**City of Biddeford
Planning Board**

May 7, 2025 at 6:00 PM
City Hall Council Chambers & Zoom

Planning Board Meeting Meeting Minutes **DRAFT**

PLANNING BOARD STAFF REPORT

Proposed Relocation Plan

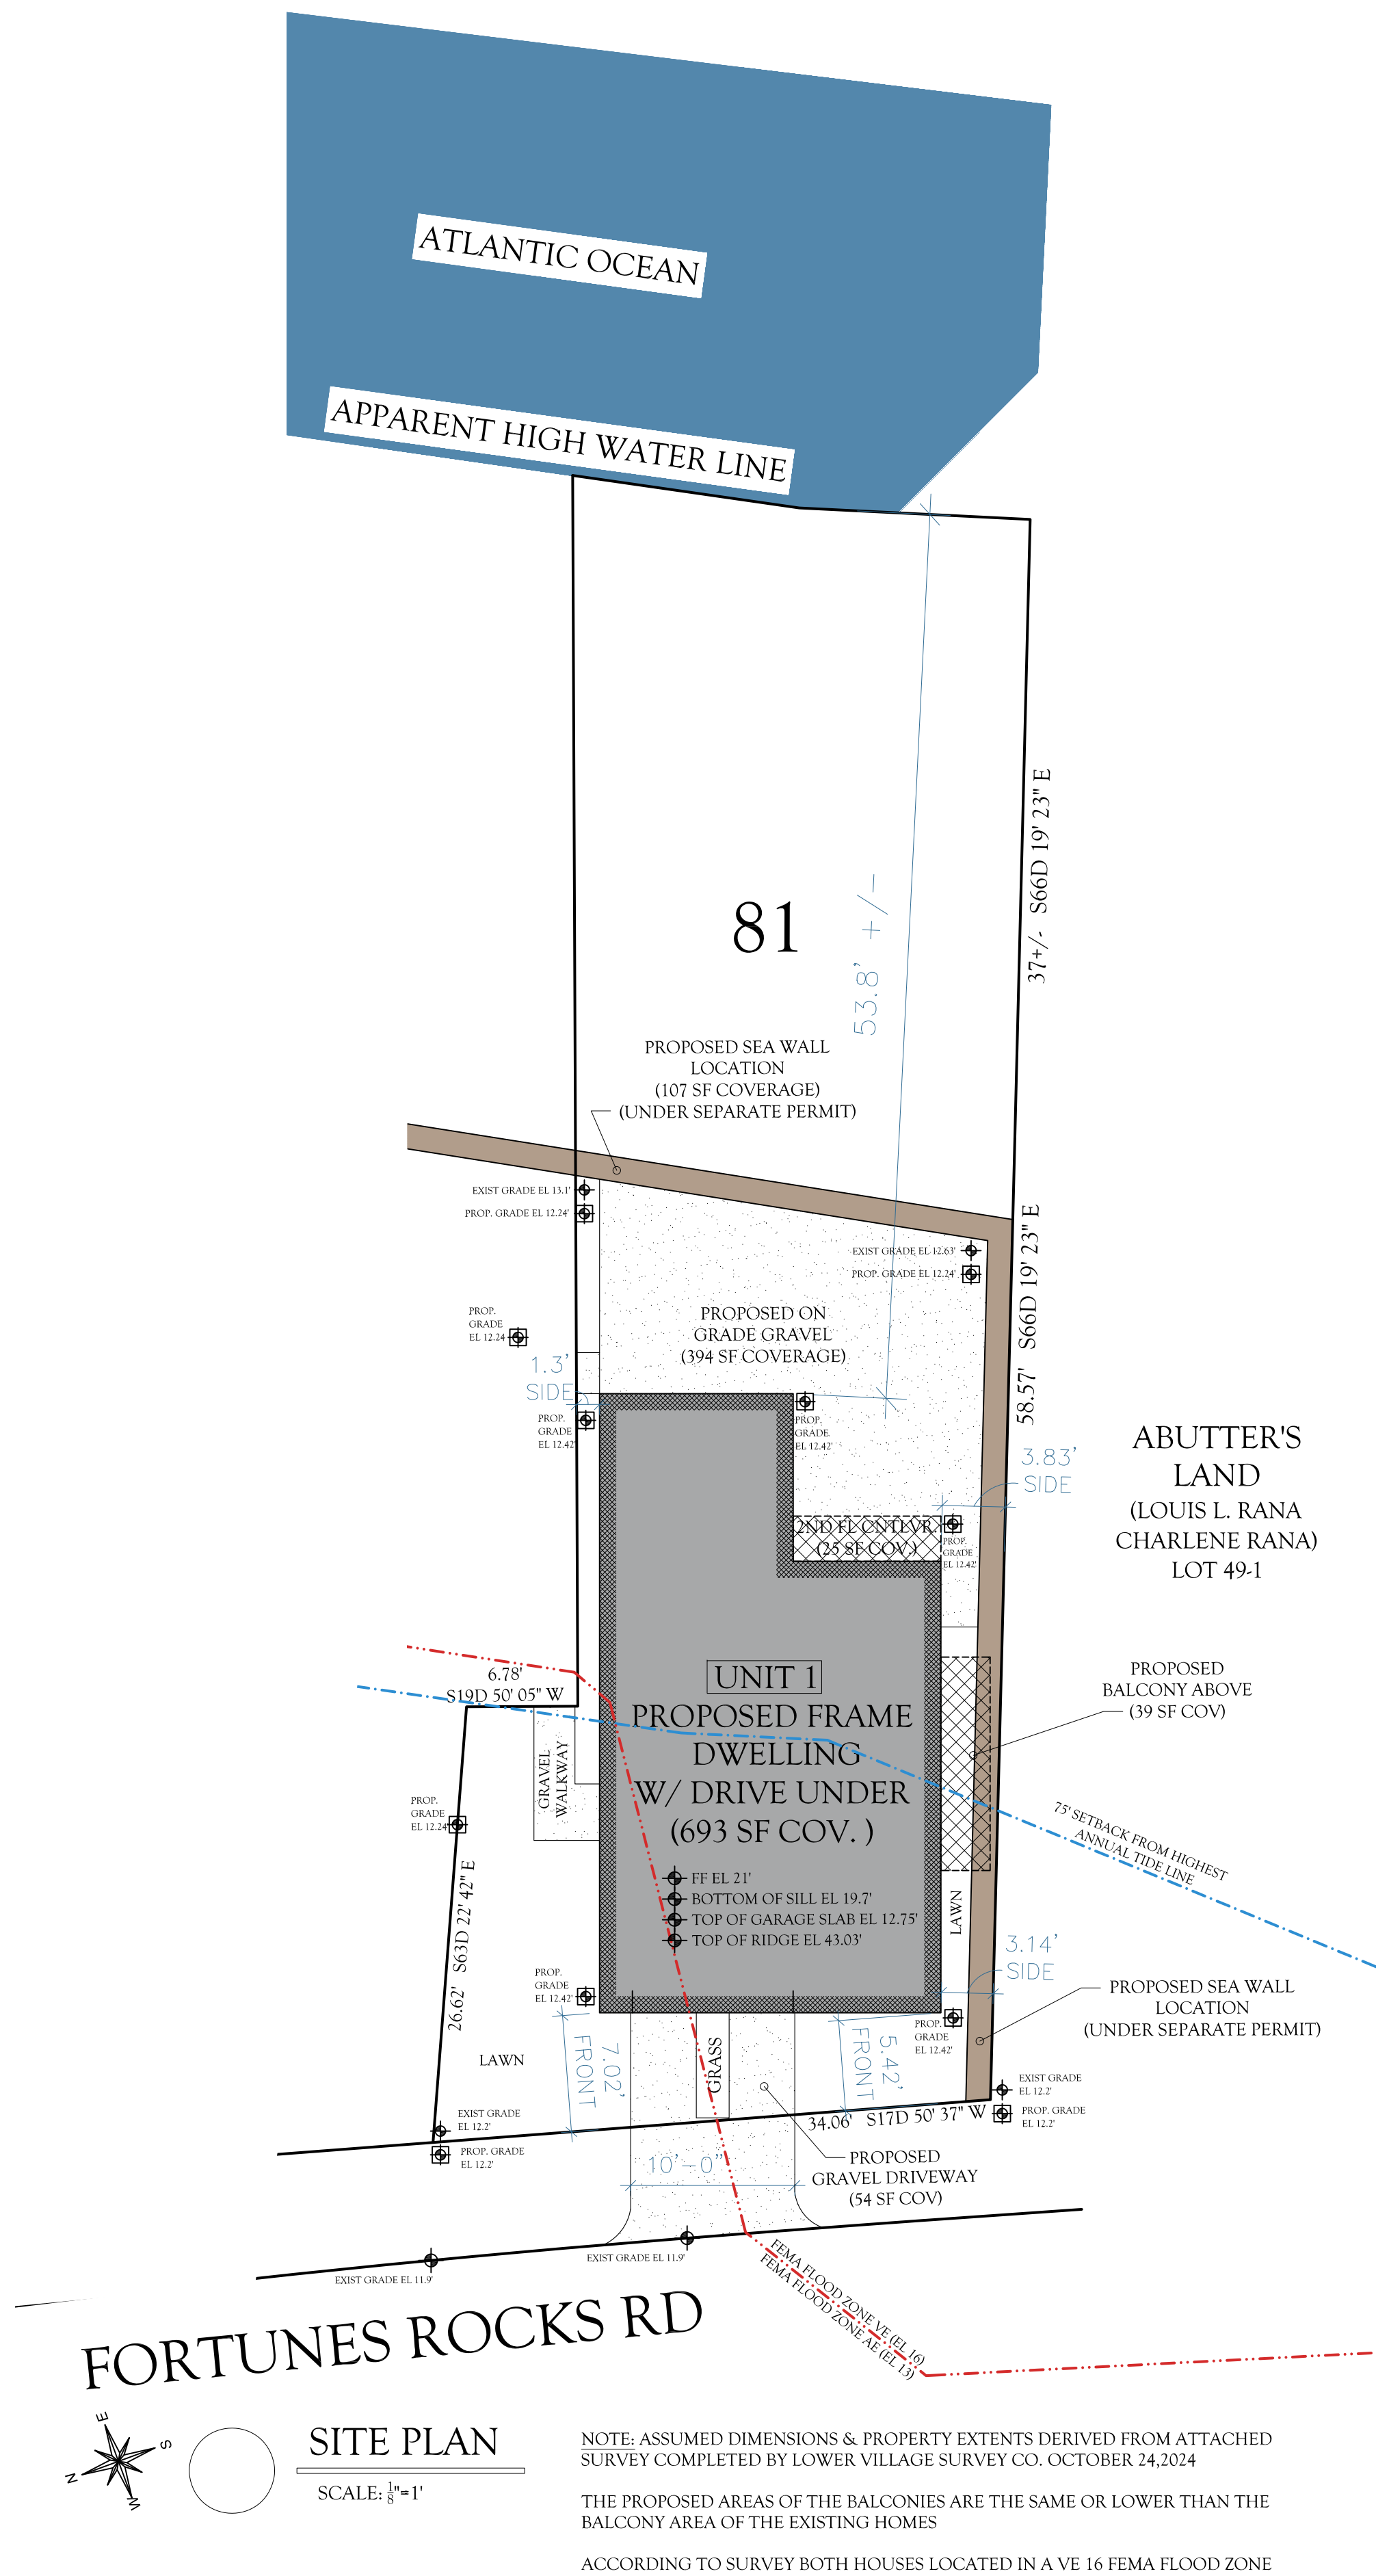
- Applicant request Planning Board approval to maintain footprints at 53.8 ft (Unit 1) and 54.7 ft (Unit 2) from the coastal wetland edge.
